QUALITY ASSURANCE -- NON-CONFORMANCE REPORT

Report No: NCR-000270

Reference Description: Missed NDT Indications by Quality Control, Segment 1AAW

Job Name: SAS Superstructure

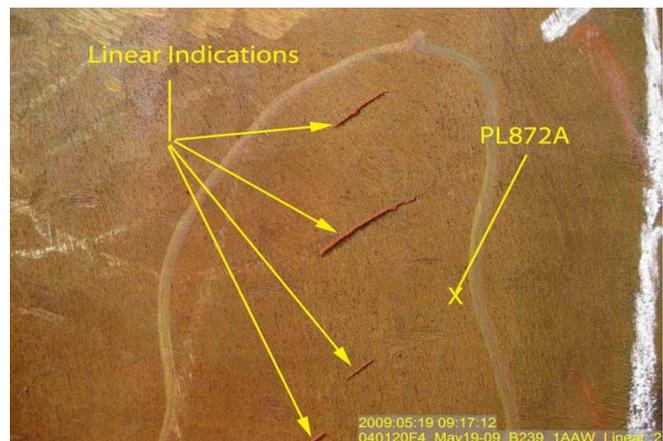
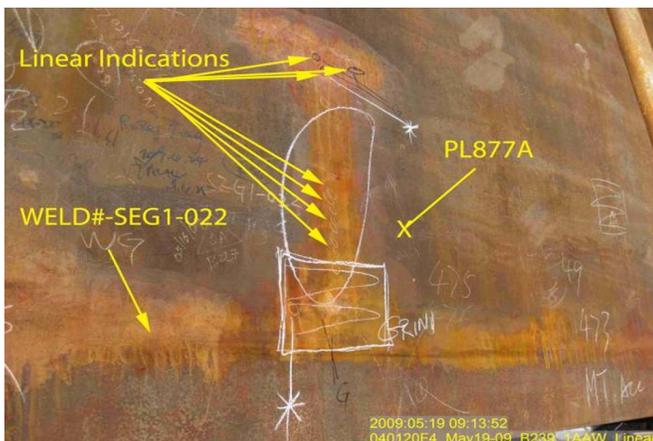
During random verification Magnetic Particle Testing (MT) of 1AAW, Top plate and Top plate to Bulkhead plate welds (SEG001-001, 017, 019, 020, 022, 023 and 026), Caltrans Quality Assurance (QA) Inspector discovered a total of forty nine (49) linear indications from 5 to 75mm in length. These areas have been previously tested and accepted by ZPMC NDT personnel.

Draft of Welding Discontinuity:

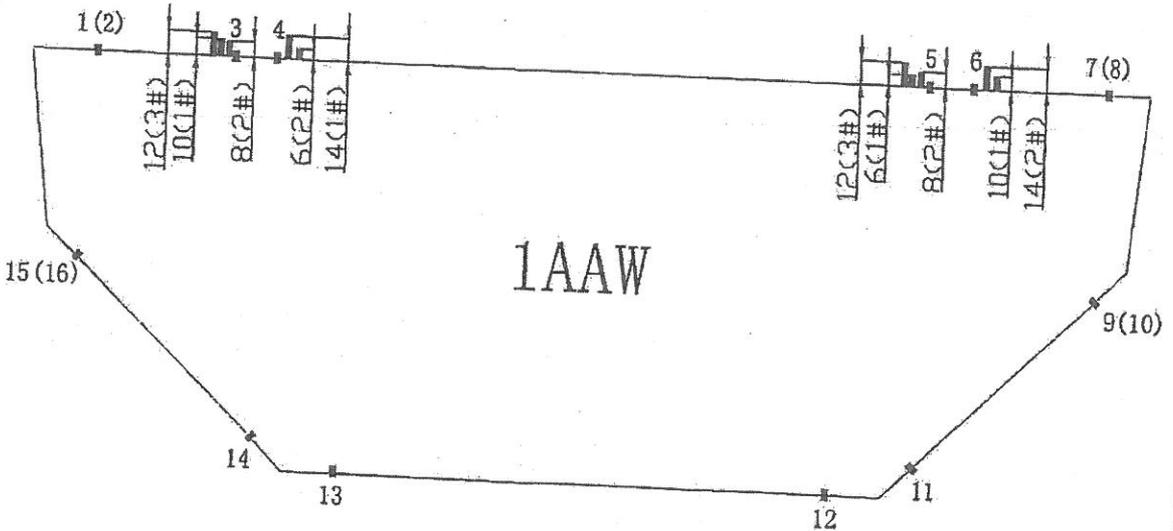
Ten transverse cracks were found by use of MT in material after removing lifting.

1、L=10mm; 2、L=8mm; 3、L=12mm; 4、L=14mm; 5、L=6mm; 6、L=6mm; 7、L=8mm; 8、L=12mm; 9、L=10mm; 10、L=14mm;

1. The tack crack was caused during assembly lifting, and cracks extended to base metal after removing lifting.
2. Welding contraction stresses and insufficient preheat and post heat control caused the crack.

1. 采用打磨的方式去除裂纹;
 2. 准备一个正确的接头型式, 具体参照相应的返修WPS;
 3. VT和MT检测确认返修区域没有裂纹;
 4. 根据批准的返修焊接工艺规程
 5. 预热温度应不小于100℃,
 6. 预热范围在修补区域周围不应小于150mm;
 7. 将修补区域打磨与母材或相邻焊缝平齐;
 8. 对修补区域做VT与MT检测.
1. Remove the crack by means of grinding.
 2. Prepare excavation according to the approved repair WPS.
 3. Verify with VT and MT repair areas are crack free.
 4. Preheat and weld according to the approved repair WPS.
 5. Preheat prior to welding to a minimum temperature of 100°C
 6. The preheat area shall be a minimum of 150mm in all directions around the repair area.
 7. Grind the repaired area flush with base metal or the adjacent weld.
 8. Perform VT and MT of the repair areas.

Draft of Welding Discontinuity:

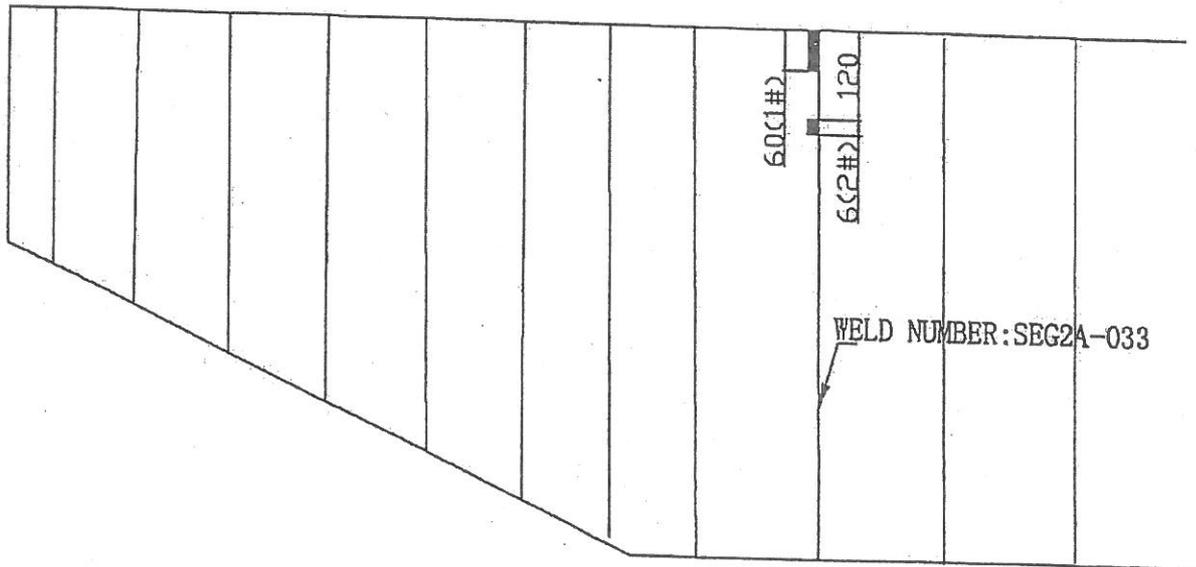
We found two longitudinal cracks in SEG2A-033.

1. 火焰加热时, 水汽没有完全的去掉或者这个区域预热不够;
1. Moisture wasn't completely removed during drying operation (preheating) or the area wasn't preheated sufficiently.

1. 采用打磨的方式去除裂纹;
 2. 准备一个正确的接头型式, 具体参照相应的返修WPS;
 3. VT和MT检测确认返修区域没有裂纹;
 4. 根据批准的返修焊接工艺规程
 5. 预热温度应不小于100℃;
 6. 预热范围在修补区域周围不应小于150mm;
 7. 将修补区域打磨与母材或相邻焊缝平齐;
 8. 对修补区域做VT与MT检测。
1. Remove the crack by means of grinding.
 2. Prepare excavation according to the approved repair WPS.
 3. Verify with VT and MT repair areas are crack free.
 4. Preheat and weld according to the approved repair WPS.
 5. Preheat prior to welding to a minimum temperature of 100°C
 6. The preheat area shall be a minimum of 150mm in all directions around the repair area.
 7. Grind the repaired area flush with base metal or the adjacent weld.
 8. Perform VT and MT of the repair areas.

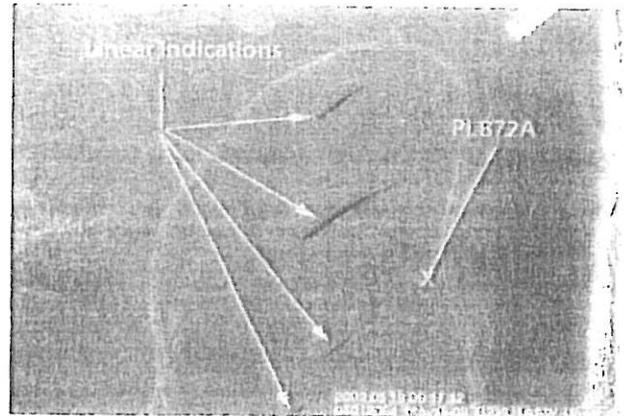
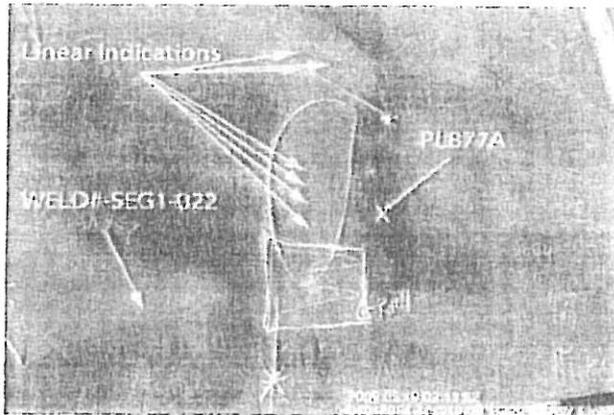
During random verification Magnetic Particle Testing (MT) of IAAW, Top plate and Top plate to Bulkhead plate welds (SEG001-001, 017, 019, 020, 022, 023 and 026), Caltrans Quality Assurance (QA) Inspector discovered a total of forty nine (49) linear indications from 5 to 75mm in length. These areas have been previously tested and accepted by ZPMC NDT personnel.

Draft of Welding Discontinuity:

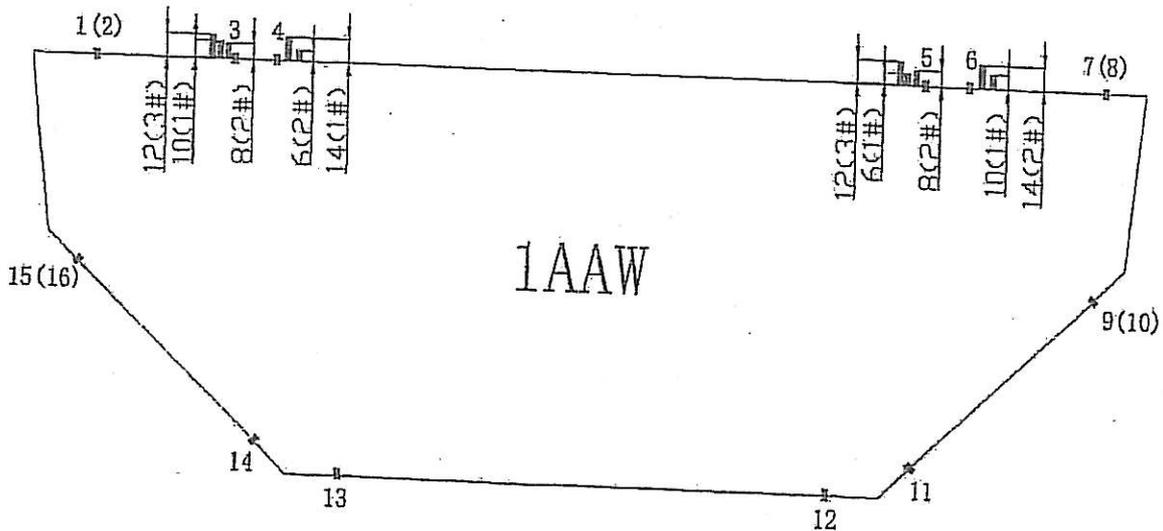
Ten transverse cracks were found by use of MT in material after removing lifting.

1、L=10mm; 2、L=8mm; 3、L=12mm; 4、L=14mm; 5、L=6mm; 6、L=6mm; 7、L=8mm; 8、L=12mm; 9、L=10mm; 10、L=14mm;

- 1. The lack crack was caused during assembly lifting, and cracks extended to base metal after removing lifting.
- 2. Welding contraction stresses and insufficient preheat and post heat control caused the crack.

- 1. Remove the crack by means of grinding.
- 2. Prepare excavation according to the approved repair WPS.
- 3. Verify with VT and MT repair areas are crack free.
- 4. Preheat and weld according to the approved repair WPS.
- 5. Preheat prior to welding to a minimum temperature of 100°C
- 6. The preheat area shall be a minimum of 150mm in all directions around the repair area.
- 7. Grind the repaired area flush with base metal or the adjacent weld.
- 8. Perform VT and MT of the repair areas.
